Rezoning Transportation Analysis

Petition Number: 2021-079

General Location Identifier: 15705136

Revision Log:

Approximate location of Proposed Pedestrian Access

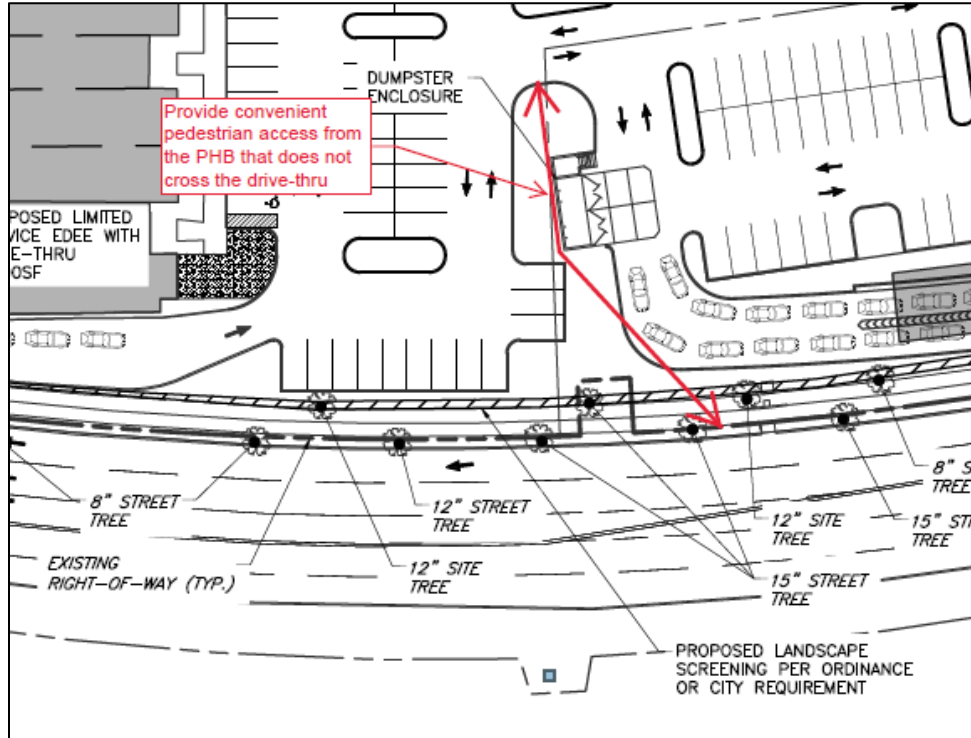
6. ~~Revise site plan and conditional note(s) to commit to provide convenient pedestrian access from the PHB into the site without crossing the drive thru.~~
